# Petone to Melling Cycleway

## Pre-Opening Road Safety Audit

28 May 2024

Figure 2: Raised crossing details from detailed designs.

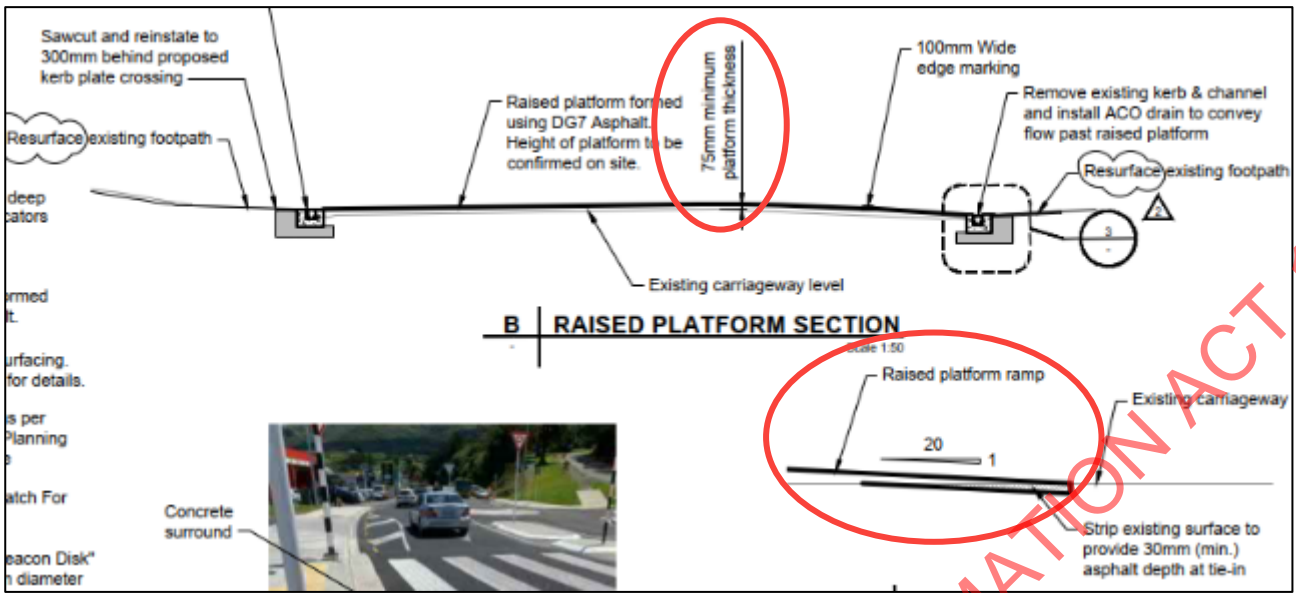
- 1 Confirm the in-situ platform height and ramp geometry in comparison to the Pedestrian Network Guidance standards, and survey vehicle speeds at the crossing.
- 2 If required, reconstruct the platform to achieve a speed reduction to at or below 30km/h.
- 3 Consider speed humps/cushions in advance of ramp.
- 4 Replace the '15' hump advisory speed supplementary plates with a more realistic speed closer to the platform geometry, i.e. '35'.

Frequency:	Severity:	Rating:
<i>Crashes are likely to be Occasional</i>	<i>Death or serious injury is Likely</i>	<i>The safety concern is Moderate</i>
<b>Designer Response:</b>	The 1:20 ramp grade was selected to allow for the type of fire trucks from the nearby station to negotiate the crossing. This does result in a faster design speed over the ramp than recommended by the Safety Auditors. The design has been altered over time to reflect changes to the TCD manual and from discussions between Waka Kotahi and the Designers. If changes are to be made to slow vehicles in advance of the crossing, the designer recommends the installation of cushions to the locations as originally designed and shown on Drawing LS-0030 Rev 5.	
<b>Safety Engineer:</b>	<b>Monitoring to assess effectiveness of raised platform could be considered. If speeds are excessive then discuss installation of speed cushions on southern approach with HCC (northern approach, road will be reconfigured by Te Awa Kairangi project). North side has better visibility. Need to consider emergency/heavy vehicles.</b> HCC: support monitoring speeds, acknowledging the signposted reduction, don't support installation of speed cushions

Figure 5: Marsden Street in the vicinity of the crossing, in June 2021 prior to crossing installation.

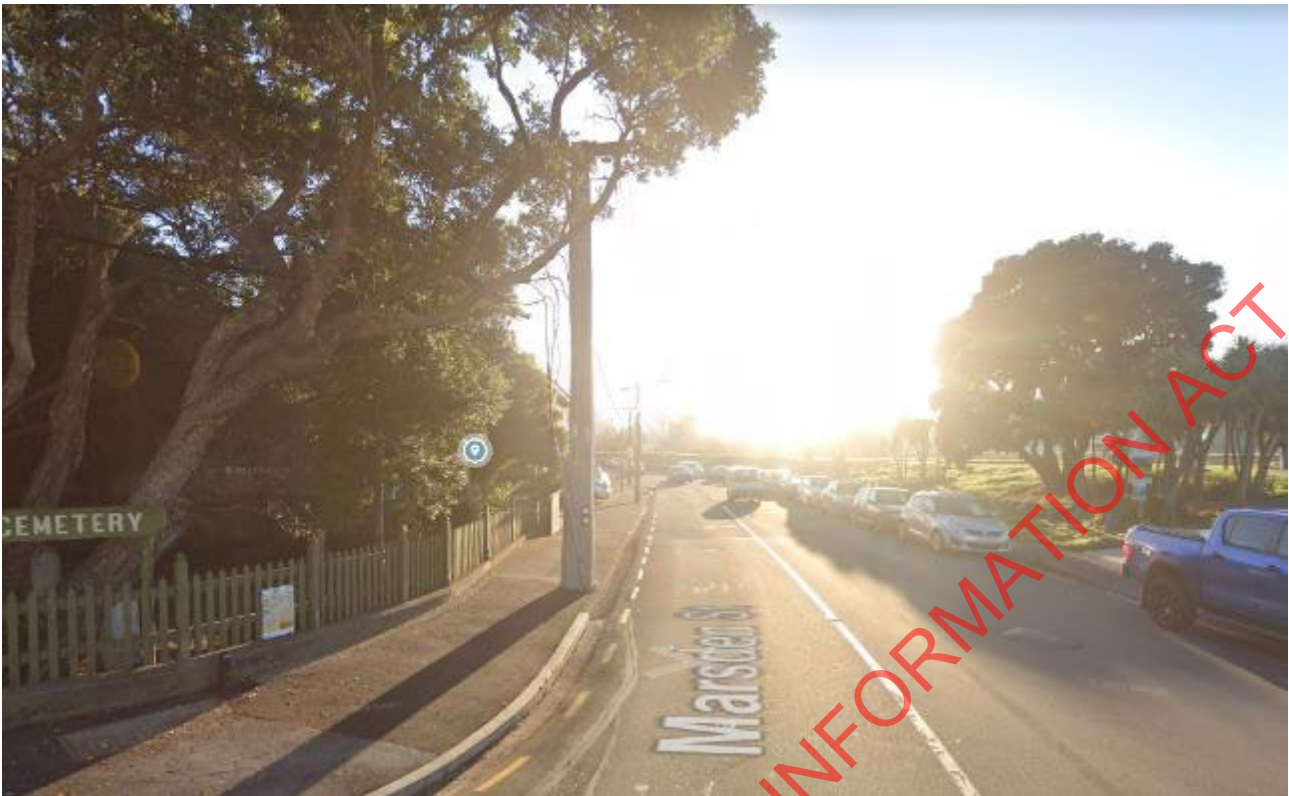
One other possible way where intervisibility may be obscured between drivers and crossing users is in the morning, when there is a risk of sunstrike due to the north-south alignment of Marsden Street aligning with the sun's position near the horizon at certain times of year. This is likely to be more of an issue in Winter when the sun rises further north and when the morning peak period coincides with sunrise. See Figure 5 below, from Google Street view in June 2021.

- 5 Remove vegetation on the Hutt River Trails approach such that drivers and cyclists both have intervisibility before entering the crossing. Approach sight distance calculations may be useful to determine how much visibility for pedestrians and cyclists is required.
- 6 Install kerb buildouts on the west side of the crossing so a pedestrian is no longer obscured behind a powerpole before crossing or relocate the power pole.
- 7 Consider local road safety campaigns in Winter advising drivers to clean windscreens and take extra care and use sunglasses or vehicle visors when travelling north during morning peak hour.

Frequency:	Severity:	Rating:
<i>Crashes are likely to be Common</i>	<i>Death or serious injury is Likely</i>	<i>The safety concern is Significant</i>
<i>Designer Response:</i>	WRT the southbound approach, the available visibility length currently meets design standard. This may change over time and is therefore a maintenance issue to be passed onto Greater Wellington Regional Council. WRT the northbound approach, a kerb build-out was not installed after consultation with Waka Kotahi correlated to cost. Originally, a flush nib kerb, together with signage in-between the existing kerb and the flush nib kerb, was designed to be installed as the hold point for pedestrians and cyclists, which gave visibility to approaching drivers that met standard (refer to Dwg TR-0021 Rev 1). The flush nib kerb, or signage in the designed position, has not been installed. The reasons for this should be explored with the site staff. Alternatively installing cushions (to the locations shown on Dwg LS-0030 Rev 5), on the approach to the crossing either in conjunction with or in lieu of, the design as shown on Dwg TR-0021 Rev 1, will help slow speeds and minimise crash severity for the situation of sun strike. In lieu of a flush kerb, bolt down wheel stops should be considered.

Figure 7: Marsden Street crossing at night.

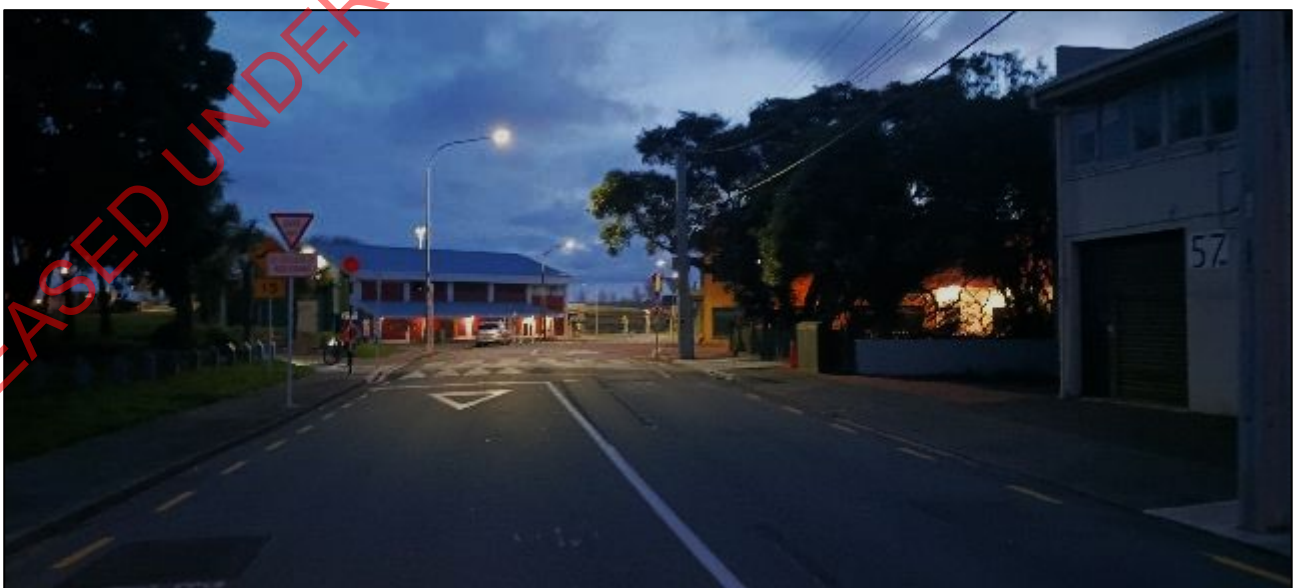
The SAT had some difficulty seeing pedestrians and cyclists using the crossing in our night inspections as pictured below.

- 10 Use a luxmeter to survey the level of lighting from the existing streetlighting on the crossing. If the minimum lux levels for a zebra crossing aren't met, replace the existing Belisha Poles with combined poles including streetlights and Belisha Discs.

<b>Frequency:</b> <i>Crashes are likely to be Occasional</i>	<b>Severity:</b> <i>Death or serious injury is Likely</i>	<b>Rating:</b> <i>The safety concern is Moderate</i>
<b>Designer Response:</b>	The Designer agrees with the Safety Auditors recommendation	
<b>Safety Engineer:</b>	Agree with the recommendation regarding surveying light levels. Belisha disks should stand out well when viewed by vehicle lights. If a street light is needed, perhaps utilise existing power pole HCC: flashing belisha should be considered. Support surveying lighting level and additional lighting on existing power pole if necessary.	
<b>Client Decision:</b>	Support additional lighting as needed. The crossing is temporary until Marsden St is realigned in 12-24 months, therefore attach temp light to power pole rather than replacing belisha infrastrucutre.	
<b>Action Taken:</b>	Included in package of works to contractor – first confirm existing lighting level against minimum requirements with lux survey.

Figure 12: Example of a diagonal pedestrian refuge (Source: TCD Manual).

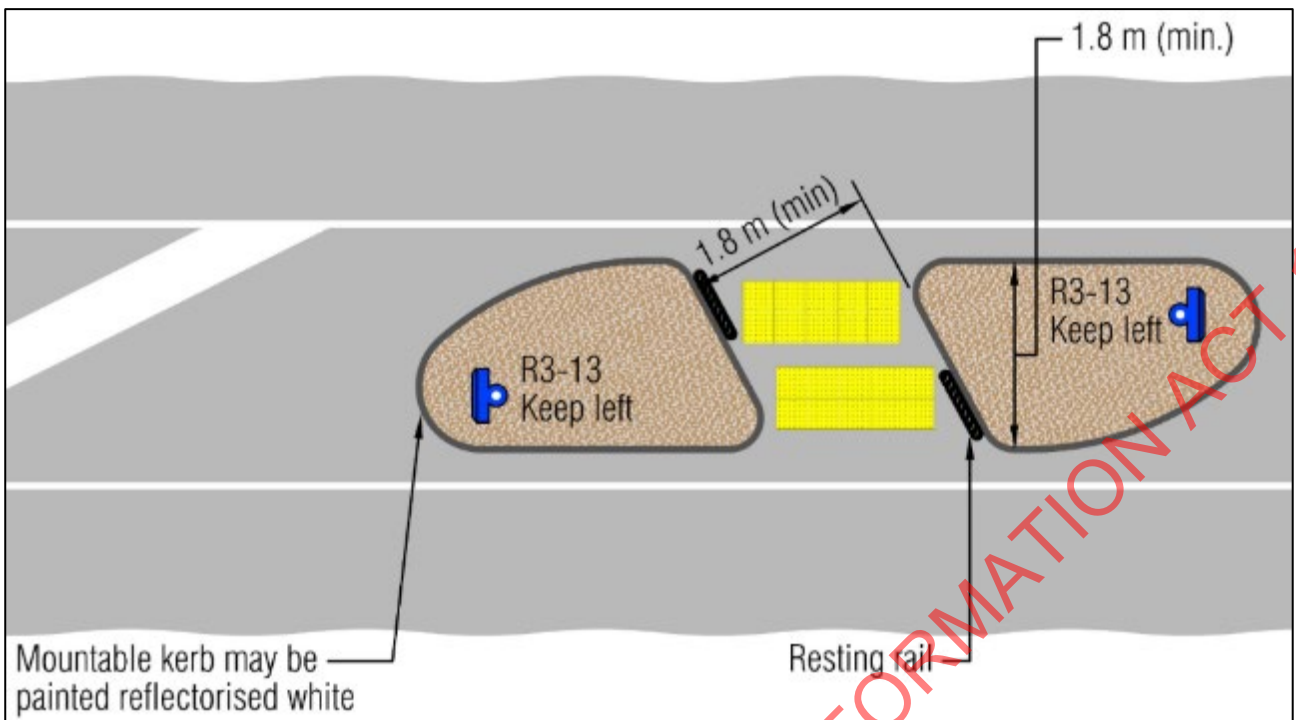
The median refuge as constructed is quite basic, missing some of the detail usually included with a refuge. There are no resting rails, no tactile pavers, and no edge markings along the side of the refuge to indicate delineation with the traffic lane. Figure 11 below shows an example of a pedestrian refuge from the TCD Manual. Note that this design is for a pedestrian only refuge. A shared path refuge is expected to be wider and deeper to accommodate bikes.

<b>Designer Response:</b>	The geometry of the crossing was governed by existing walls, narrow path widths and vehicle swept paths. A raised platform or roundabout was rejected by HCC and GWRC due to bus driver responses during consultation. Traffic volumes and movements did not meet the threshold for signalling the intersection and was not supported by HCC. Resting rails to the median refuges are a hazard to bus/truck turning swept paths and vehicles with load overhang. The Designer agrees that pedestrian tactile pavers and edge markings can be installed to the median refuge area over half the width. Vegetation clearance should be explored with HCC and trimmed to provide visibility that meets current standard. Installing cushions on Normandale would reduce crash severity between cyclists/pedestrians and vehicles and would mitigate most of the concerns raised by the Safety Auditors.
<b>Safety Engineer:</b>	Agree with designer's comments to paint edgelines to improve refuge delineation, however pedestrian tactile pavers could be a slip hazard. Agree with trim vegetation to improve visibility. Agree with recommendation for speed cushions on Normandale Road. HCC: Proceed with the design of a mountable refuge island, with no resting rails as these devices are likely to cause damage to drivers of large vehicles turning at the intersection. HCC is supportive to the installation of edge lines. Tree trimming is supported to improve visibility of the intersection, please progress with this work. The installation of speed cushions is not supportive due to structural and budget constraints. Confirm tracking curves. If vehicle tracking allows, tighten curve on the eastern side to allow more waiting space.

<b>Client Decision:</b>	Trim vegetation to improve sightlines and add this to the Asset Owner's Manual landscaping maintenance schedule. Paint edge lines at the median refuge. Speed cushions and curve changes deferred. To be considered by HCC as part of any future intersection improvements.
<b>Action Taken:</b>	Tree trimming and edge lines included in package of works to contractor

Figure 13: Intervisibility of path between southbound vehicles approaching intersection and shared path on western side of crossing (circled in red).

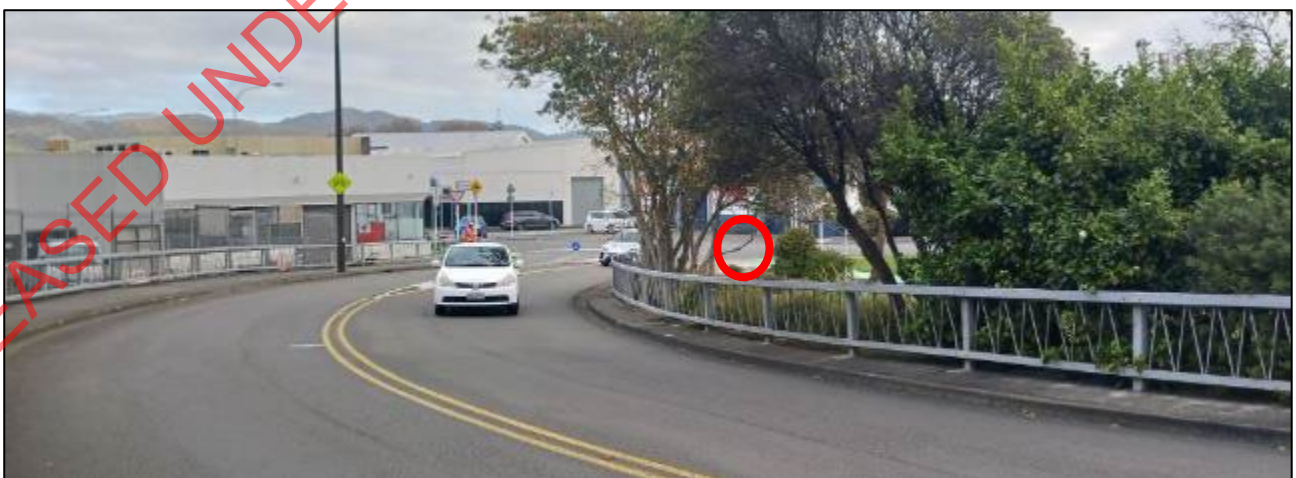
The intervisibility between path users on the west side of the intersection and south-bound traffic on Normandale Road is limited, due to the vegetation in The Greenway. The median refuge means that path users can cross in two movements, reducing the risk created by the limited visibility. For pedestrians, Normandale Road is probably safer to cross than it was before the refuge was constructed.

However, due to the limitations of the median refuge described above, many path users, particularly those on bikes, are likely to prefer to cross in one movement. In which case, visibility from each end is much more important. There are numerous conflict points to check (including looking back over shoulder) before crossing. The sight distance between a southbound vehicle on Normandale Road and a path user on the western side of the crossing is about 45m through a gap in the vegetation.

Figure 19: Correct high-use driveway treatment for cycle paths and shared paths.

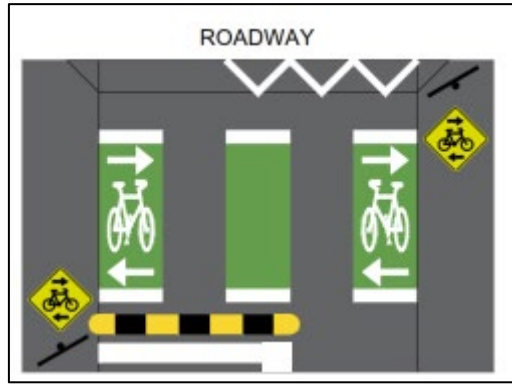
WU61 signs have been placed at the driveways to alert drivers to the presence of cyclists travelling in both directions. The SAT considers these signs could be better placed to better align with the guidance. The recommended layout is shown in Figure 18 below.

The WU61 signage poles should be located clear of the cycle path or shared path, and pointing in a direction that faces an oncoming driver. The placement of the poles on Bridge Street are within the shared path which increases the risk of a cyclist crash if they hit the pole with their handlebars.

<b>Frequency:</b> Crashes are likely to be Common	<b>Severity:</b> Death or serious injury is Unlikely	<b>Rating:</b> The safety concern is Moderate
<b>Designer Response:</b>	Signs were placed in accordance with current standards. Considering that the signs face the roadway, the Designer agrees that these signs can be relocated to align with the existing edgeline.

Figure 25: Entrance to Petone underpass at either end.

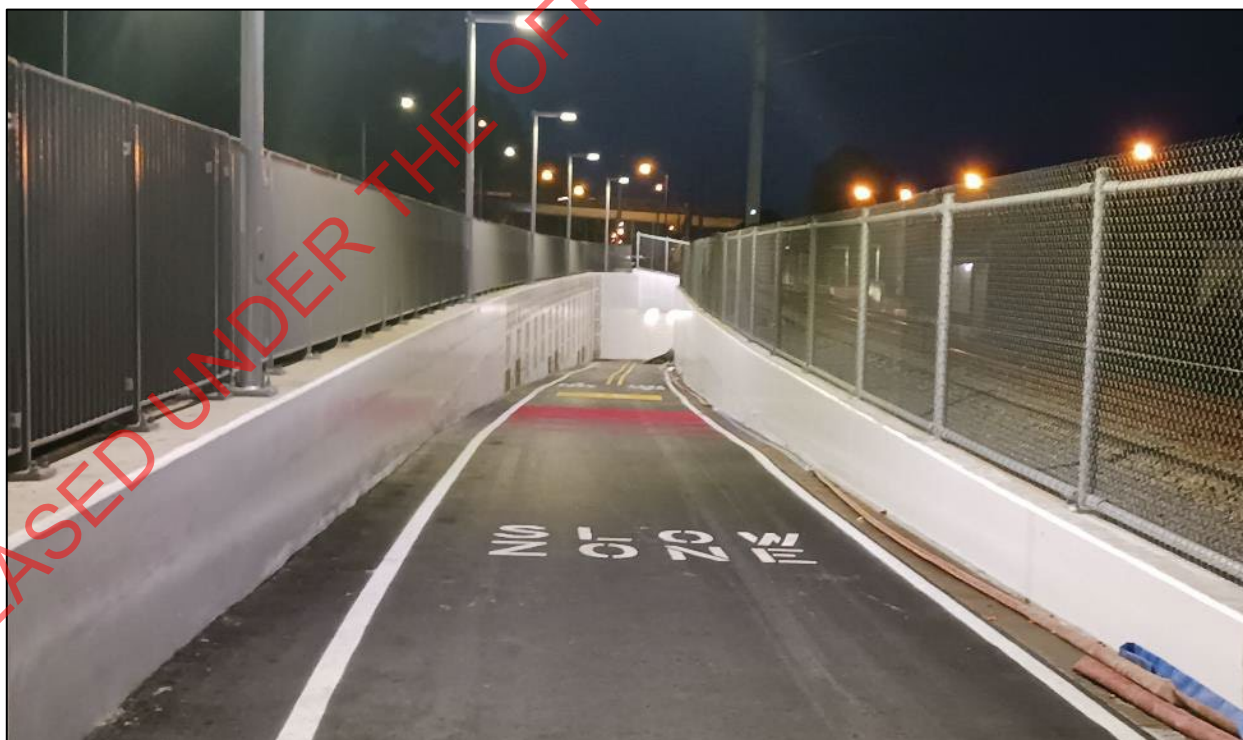
- 39 Install physical measures to reduce cyclist speeds on the ramps entering the underpass, e.g. similar to the Kent/Cambridge Terrace bumps outside the fire station.
- 40 Undertake monitoring post-opening including speeds and behavioural monitoring to identify near misses or if travel speeds are likely to result in serious injury (impact speed above 30km/h, i.e. cyclists in opposing directions both going above 15km/h or similar). This will provide immediate information to manage risk so that additional measures such as convex mirrors, electronic warning signs and depth perception aids (tunnel wall stripes or similar) can be installed quickly if required.

Frequency:	Severity:	Rating:
<i>Crashes are likely to be Common</i>	<i>Death or serious injury is Likely</i>	<i>The safety concern is Significant</i>
<i>Designer Response:</i>	In consultation with cycle groups during consenting, the provision of physical measures at underpass portals was rejected and the Resource Consent application did not include any physical measures. The Designer agrees with Recommendation 40 and if there is a safety issue, the information gathered can be used as evidence to overturn cycle groups objections and additional measures as recommended by the Safety Auditors considered.	
<i>Safety Engineer:</i>	Existing markings are adequate. Monitor and if there are serious problems then additional measures can be considered.	
<i>Client Decision:</i>	Lane tracking data collected post-opening indicates a good level of compliance >91% at the ramp approach, meaning good behaviours are helping to reduce this risk. No action at this stage.

Figure 28: Possible hazard at northern end of Petone underpass.

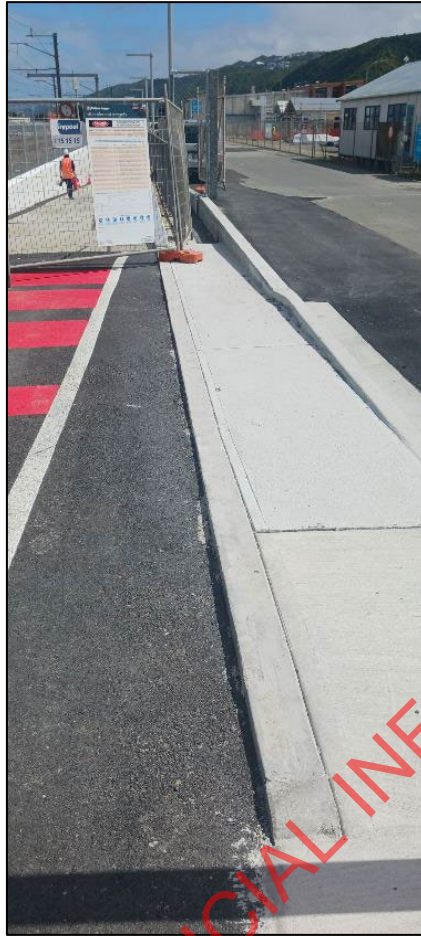
There are several areas in the vicinity of the underpasses where minor differences in the height between the footpath, carriageway and underpass ramp could trip pedestrians, as the height difference is not sufficiently large (e.g. a kerb is 100mm high) that pedestrians may notice the difference in levels.

- 44 Remove trip hazard by levelling surface or providing an obvious step-down if necessary. If this is not possible, then consider delineating the step down e.g. with tubular delineators or similar.

<b>Frequency:</b> <i>Crashes are likely to be Occasional</i>	<b>Severity:</b> <i>Death or serious injury is Very Unlikely</i>	<b>Rating:</b> <i>The safety concern is Minor</i>
<b>Designer Response:</b>	The Designer agrees with providing delineation at the locations where there is an obvious step-down.	
<b>Safety Engineer:</b>	<b>Confirm if there is a step-free egress point nearby. Make it more conspicuous, if need be.</b>	
<b>Client Decision:</b>	This step is not an egress point and has no strong desire lines therefore no action for this trip hazard. Confirmed egress point to carpark is conspicuous.	
<b>Action Taken:</b>	nil

Figure 29: Example of debris build-up on path adjacent to gravel berm

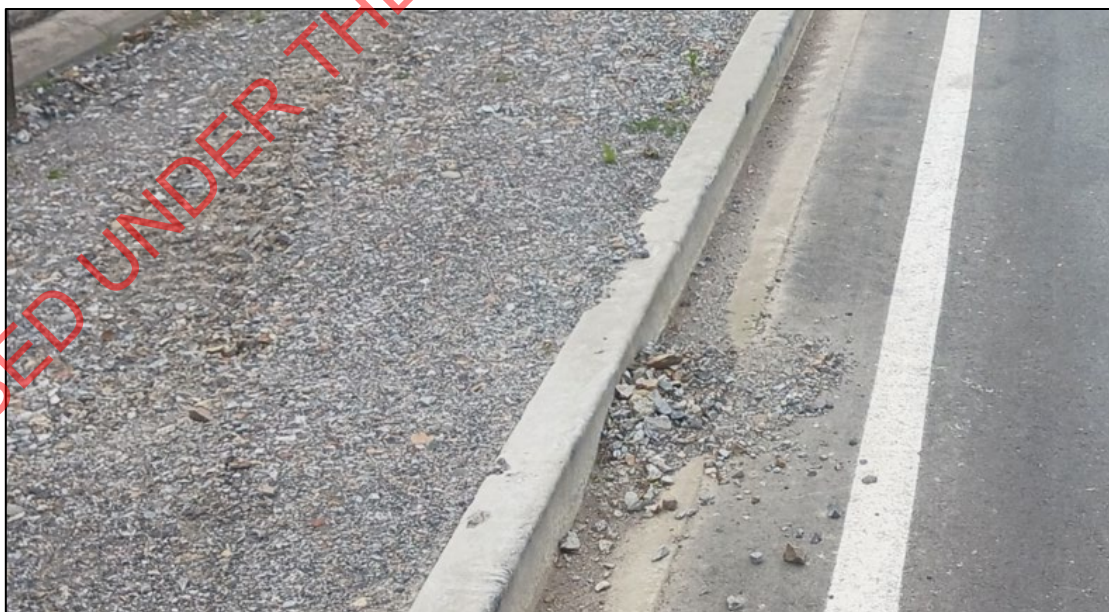
The cycle path is between the rail corridor and the state highway. On both sides, there are gravel berms. This gravel is likely to migrate onto the cycle path on a frequent basis due to rainfall events and tracking by maintenance vehicles using the corridor and berm. If left unmaintained, the build-up of debris may lead to cycle loss-of-control crashes.

<b>Frequency:</b> <i>Crashes are likely to be Common</i>	<b>Severity:</b> <i>Death or serious injury is Unlikely</i>	<b>Rating:</b> <i>The safety concern is Moderate</i>
<b>Designer Response:</b>	The Designer agrees with Recommendations 50 and 51.	
<b>Safety Engineer:</b>	Agree	
<b>Client Decision:</b>	Levels of service for keeping the path well-swept are part of the maintenance agreement with HCC. No further action.	
<b>Action Taken:</b>	nil

Figure 35: RG-17 sign that could be installed to remind northbound riders to stay right of the southbound bypass lane.

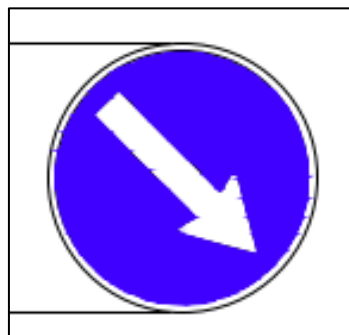
The SAT anticipate confusion of how the cycle path layout works in this area would be more of a useability issue than a safety issue, as there are good sightlines for oncoming cyclists so riders would moderate their speeds and behaviour.

Frequency:	Severity:	Rating:
<i>Crashes are likely to be Infrequent</i>	<i>Death or serious injury is Unlikely</i>	<i>The safety concern is Minor</i>
<b>Designer Response:</b>	The entry point to the cycle bypass has been designed in consultation with Waka Kotahi. The entry point is not a designated location for northbound cycle path users to access Maungaraki via the SH southbound exit slip to Dowse interchange. There is no formal access provided to Maungaraki as part of the P2M project, hence there no guidance was provided for cyclists to undertake this manoeuvre. To guide northbound cycle path users not to enter the southbound entry slip at the cycle bypass exit or the southbound exit slip at the cycle bypass entry, the Designer recommends that the signage as shown on Dwgs LS-0025 and LS-0027 be installed. The Designer agrees with Recommendation 57. The Designer agrees with Recommendation 58 but recommends these signs be installed on the appropriate ends of the guardrail that separates the cycle path from the cycle bypass.

<b>Safety Engineer:</b>	Suggest adding a white arrow in the southbound lane adjacent to the first post in figure 34. If ongoing problem can resort to RG-17. Prefer markings alone as RG-17 can introduce a snag risk.	
<b>Client Decision:</b>	Install white southbound arrow in the southbound lane adjacent (SH2 side) to the first post in figure 34.	
<b>Action Taken:</b>	Included in package of works to contractor.
